**CECIL COUNTY, MARYLAND  
BID NO. 10-41-53004**

**WOODLAWN TRANSFER STATION  
SITE IMPROVEMENTS**

**ADDENDUM No. 1  
March 3, 2010**

**Maryland Department of Transportation**  
**STATE HIGHWAY ADMINISTRATION**  
 STANDARDS FOR HIGHWAYS AND INCIDENTAL STRUCTURES  
**PRECAST TEMPORARY 32 INCH**  
**F SHAPE CONCRETE TRAFFIC BARRIER**  
**(PIN AND LOOP JOINT)**  
**STANDARD NO. MD 104.01-53**

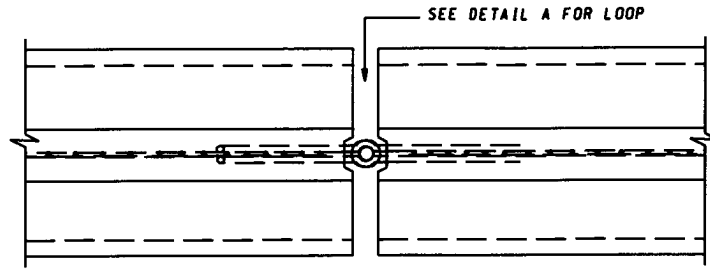
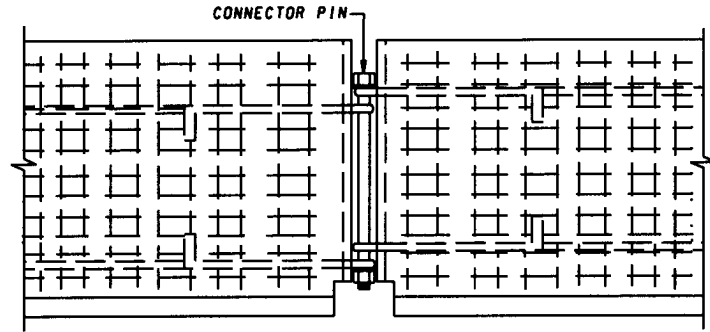
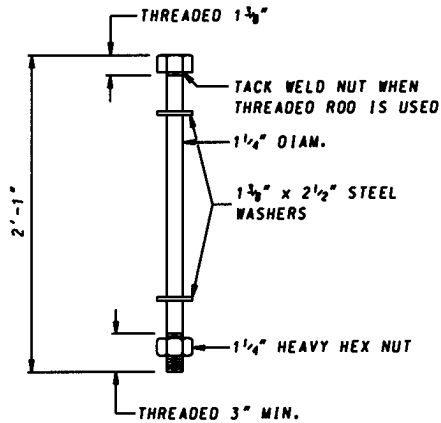
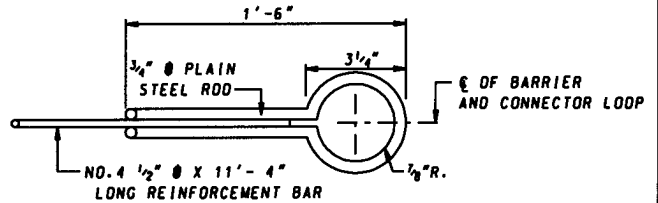
11. Is there a detail of the 32 inch Temporary Concrete Barriers available?

**Temporary concrete barriers shall be provided per SHA Standard Specifications. SHA Standard details are provided as an attachment to this addendum.**
